**Development Application: 216-220 Wyndham Street, Alexandria - D/2023/884**

**File No.: D/2023/884**

**Proposal Summary:** Approval is sought for a concept proposal for a mixed use development comprising the following:

**Figure 28:** Proposed massing strategy for the concept envelope prepared by Bates Smart (as lodged)

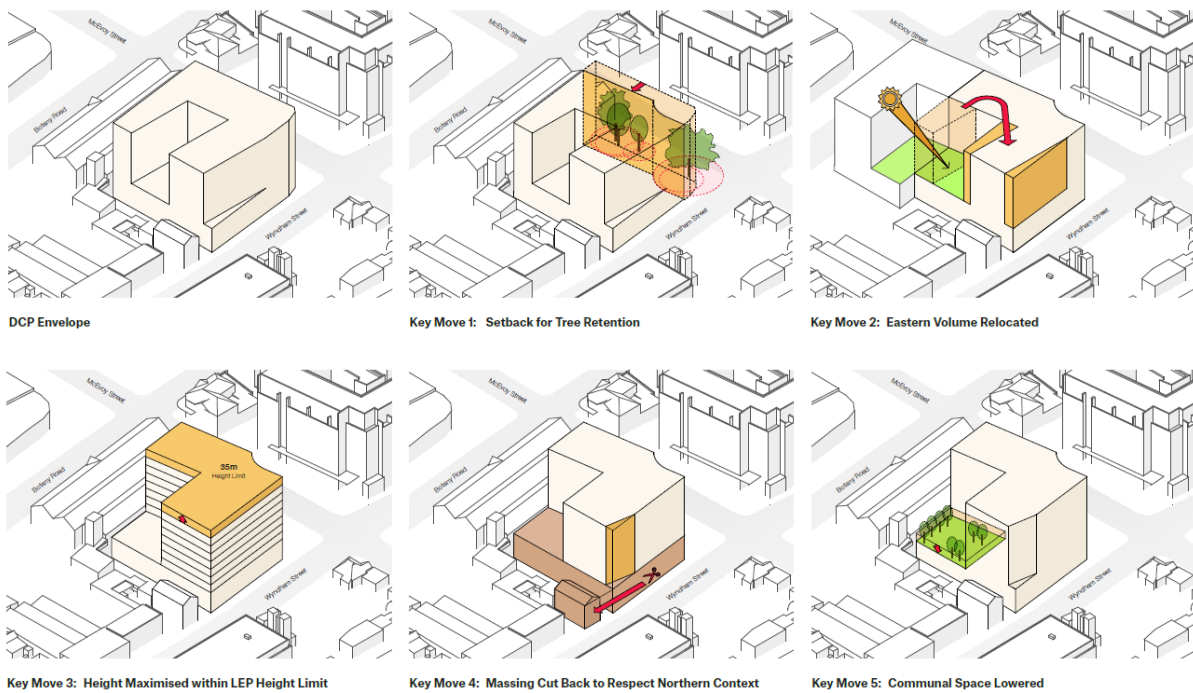
70. The above DCP height in storeys map envisages a U-shape tower form above a two storey podium, setback 3m from the southern McEvoy Street boundary and an 8 storey form along the eastern boundary. The part 8, part 9 storey form on the western side is partly setback above the podium to improve solar orientation for upper levels.
71. The application seeks consent for an alternative massing strategy, which was developed with the objective of retaining existing high retention value trees on the McEvoy Street frontage. Diagrams showing the applicant's overarching massing strategy (as lodged) is provided in Figure 28 below.

72. The following key moves form part of the applicant's massing strategy:
- (a) Setback for tree retention - The southern setback is increased from 3m to 10m to retain existing trees on McEvoy Street and consolidate deep soil.

Figure 30: Location of existing trees on the site

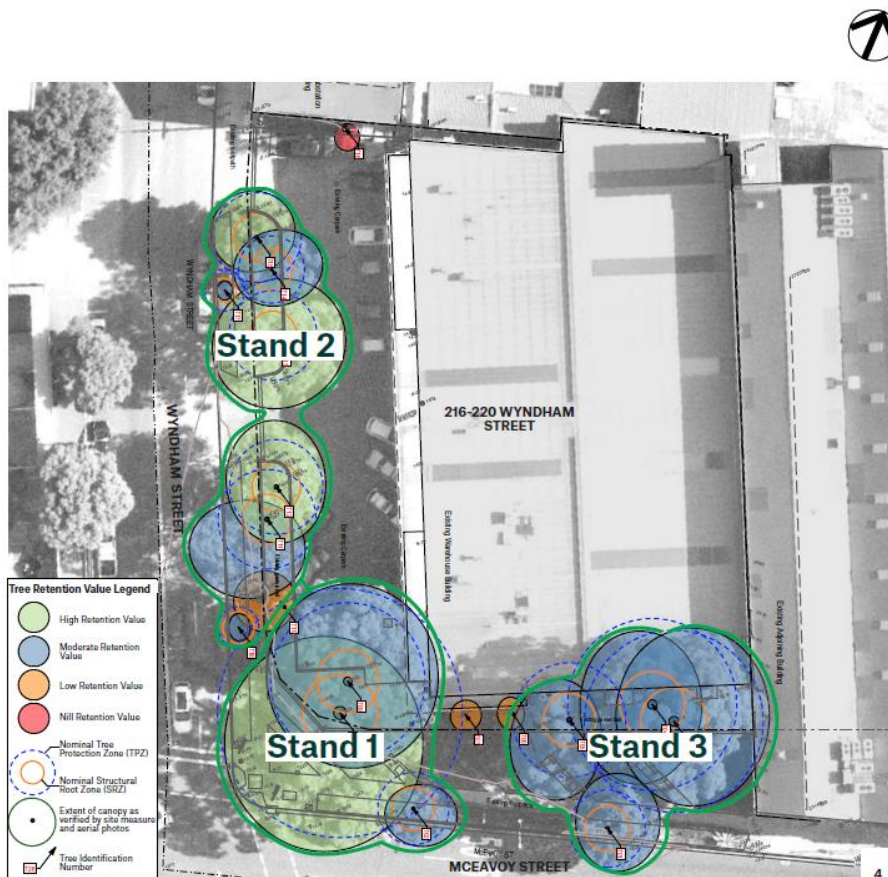
82. The proposed Concept Plan shows the indicative removal of trees on the Wyndham Street frontage (Trees 10-16, also described as Stand 2) as well as two small low-significance trees on the McEvoy Street frontage (Trees 6 and 7).

84. The City's Tree Management unit indicated preference for the retention of the existing trees on Wyndham Street as these trees have high retention value and provide significant benefits to the local environment. Notwithstanding, it was noted that if the removal of the Stand 2 trees is supportable, the following is required:

- (a) The removal of trees is offset by the planting of new canopy trees.
  - (b) The significant trees on McEvoy Street must be retained and protected. These trees hold substantial canopy and greatly contribute to the site's canopy cover requirements. An adequate building setback must be provided adjacent to Trees 1-9 and the design of the building must consider the Tree Protection Zone and canopy width. Construction scaffolding and hoarding must also be considered.

**Figure 31:** North-south section through the laneway, showing the development potential of neighbouring sites to the north (note that the heritage substation has a 4 storey height control)

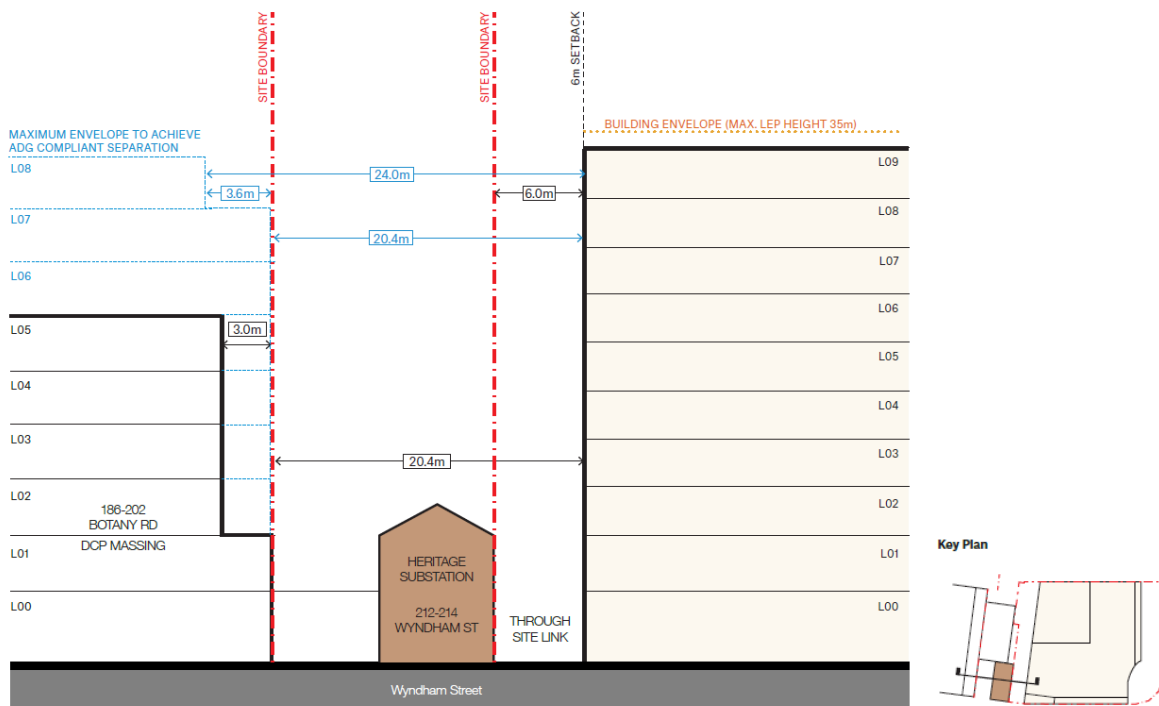
- 90. Council's Request for Information advised that the 6m setback for the first four storeys is in keeping with the ADG, however, the development would need to provide a 9m setback on floors 5-8 and a 12m setback on floors 9+ to achieve compliance with the ADG.

- 91. Notwithstanding the above, it was acknowledged that the adjoining site to the north is a heritage item and has limited development potential. Therefore further information was requested that investigates the full development potential of the adjoining heritage site at 212-214 Wyndham Street (across the entire site, not only where the substation is located) and at 186-202 Botany Road further north.

93. The entire heritage substation site (including the area to the east of the heritage building) is subject to a maximum FSR of 1:1 and maximum height of buildings control of 15m under the LEP and a 4 storey building height under the DCP. This site does not benefit from uplift controls within the Botany Road Precinct as it is a heritage item. Therefore the 6m setback to any likely future development on this site is considered adequate.

**Figure 32:** DCP map with the site outlined in blue and 8 storey southern street wall outlined in pink

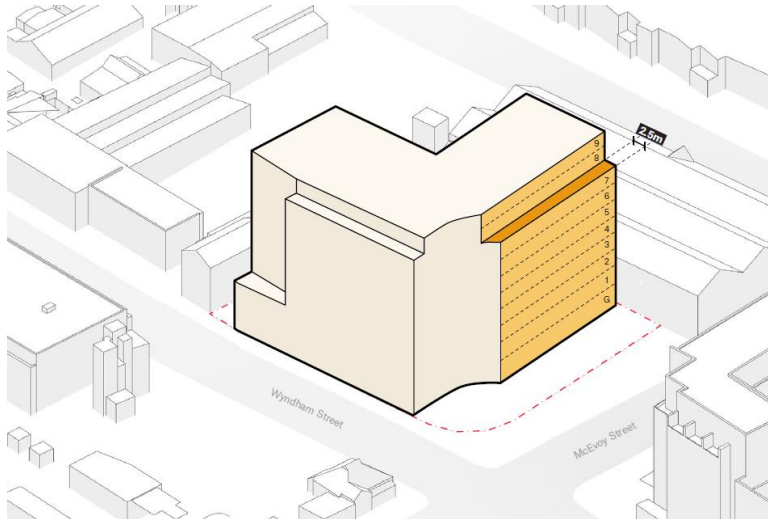
98. The concept plans as submitted proposed a 10 storey form across McEvoy Street, which would exceed the DCP control by two storeys on this part of the site.

99. Council's Request for Information recommended that an upper level setback be provided for any storeys above the 8 storey DCP height on the McEvoy Street frontage, in order to minimise the perceived bulk of the building and to provide a continuous 8 storey street wall with likely future development at 204-218 Botany Road.
100. The amended plans incorporate an 8 storey street wall on the southern facade, with the upper two levels setback 2.5m. This is considered acceptable for the purpose of the concept envelope.

**Figure 34:** Amended setbacks proposed to Wyndham Street

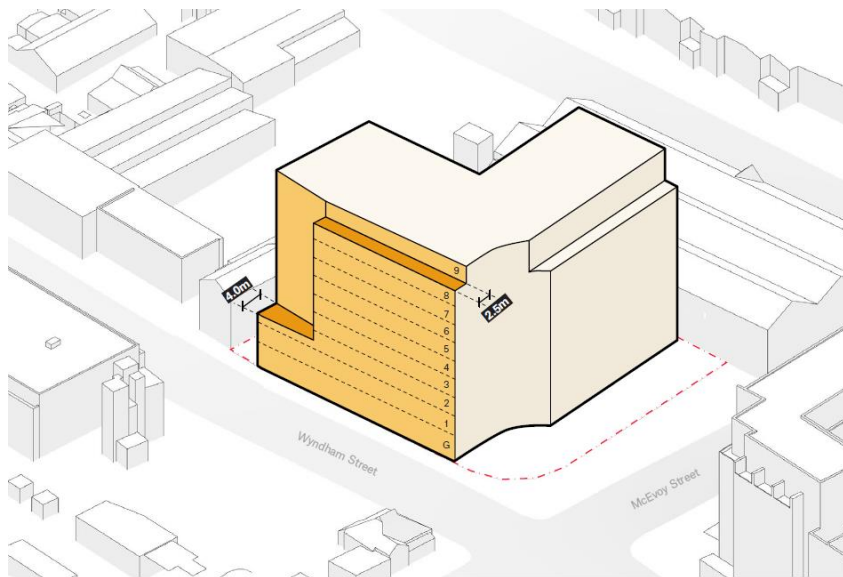
103. The DA as submitted proposed a 10 storey wall fronting Wyndham Street, with a partial 2 storey street wall on the north-western corner.
104. Council's Request for Information recommended that in this instance, an upper level setback should be provided for any storeys above the 9 storey DCP control on Wyndham Street to minimise visual impact and to maintain the 9 storey street wall in the DCP.

105. In response, amended plans were submitted that introduced a 9 storey street wall to the western facade, with the 10th storey setback 2.5m. The depth of the two storey 'shoulder' was also increased to 4m to provide greater transition to the heritage item.

106. The introduced setbacks to the western frontage are generally acceptable as the 9 storey street wall to Wyndham Street is consistent with the DCP height in storeys, with the upper level now being setback.
107. Compliance with ADG separation and consideration of potential future development on the adjoining site to the west will be undertaken as part of the detailed design DA.
